Planning and Development Services
Arun District Council
Arun Civic Centre
Maltravers Road
Littlehampton
West Sussex
BN17 5LF

Developer Services
Southern Water
Sparrowgrove House
Sparrowgrove
Otterbourne
Hampshire
SO21 2SW

Your Ref
EG/59/17/HH
Our Ref
PLAN-019662
Date
15/09/2017

Proposal: Single storey rear extension.
Site: 4 Wentworth Close, Barnham, PO22 0HS.
EG/59/17/HH

O.S. REF: SU9505SE

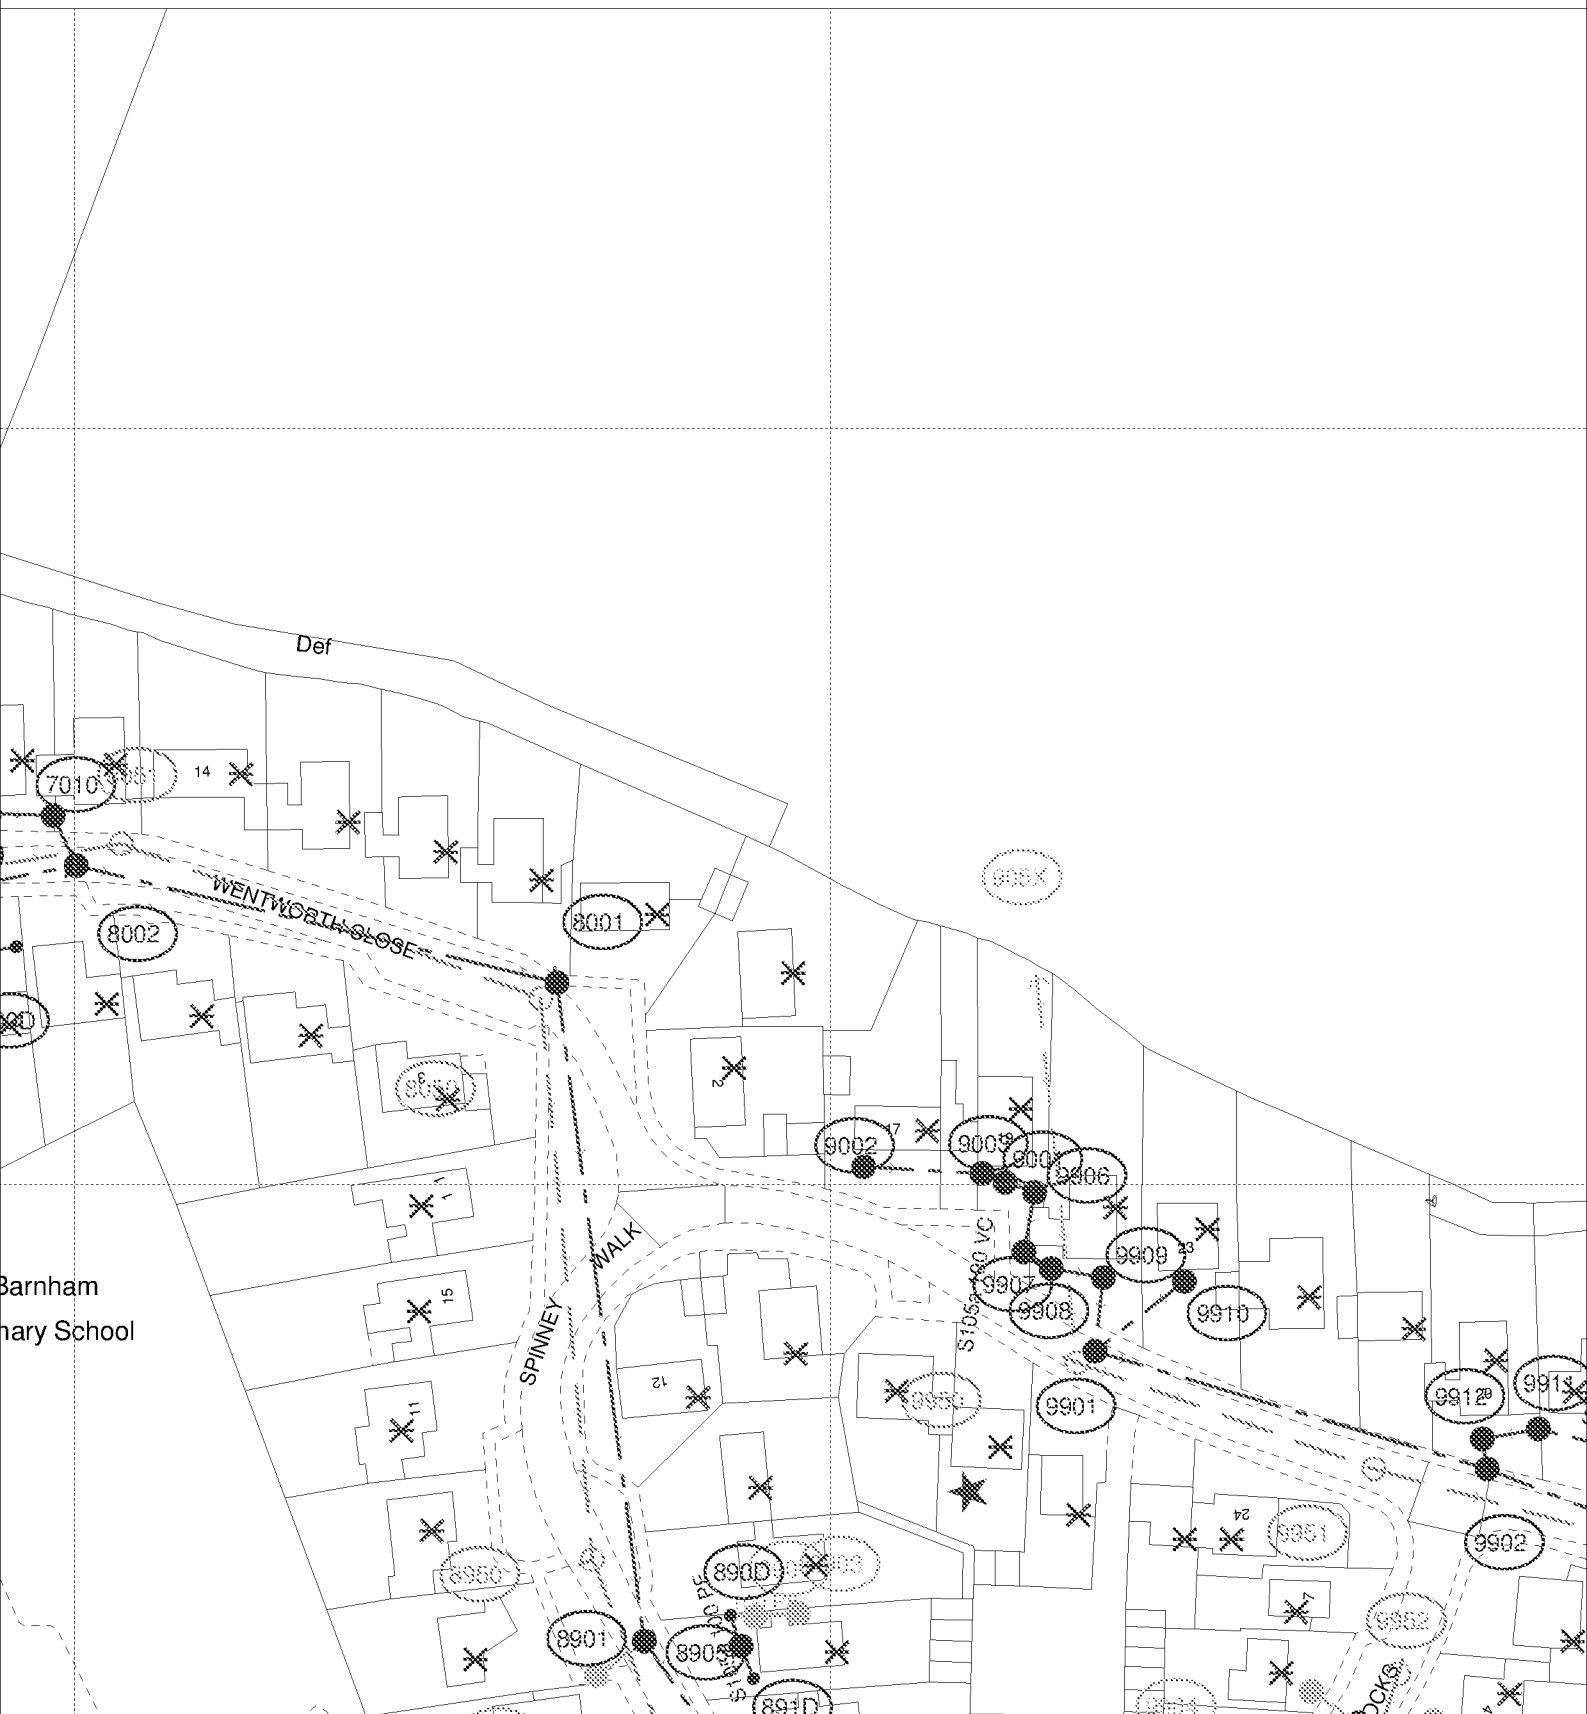
Southern Water requires a formal application for a new connection to the public foul sewer to be made by the applicant or developer.

Due to changes in legislation that came in to force on 1st October 2011 regarding the future ownership of sewers it is possible that a sewer now deemed to be public could be crossing the above property. Therefore, should any sewer be found during construction works, an investigation of the sewer will be required to ascertain its condition, the number of properties served, and potential means of access before any further works commence on site.

The applicant is advised to discuss the matter further with Southern Water, Sparrowgrove House Sparrowgrove, Otterbourne, Hampshire SO21 2SW (Tel: 0330 303 0119) or www.southernwater.co.uk.
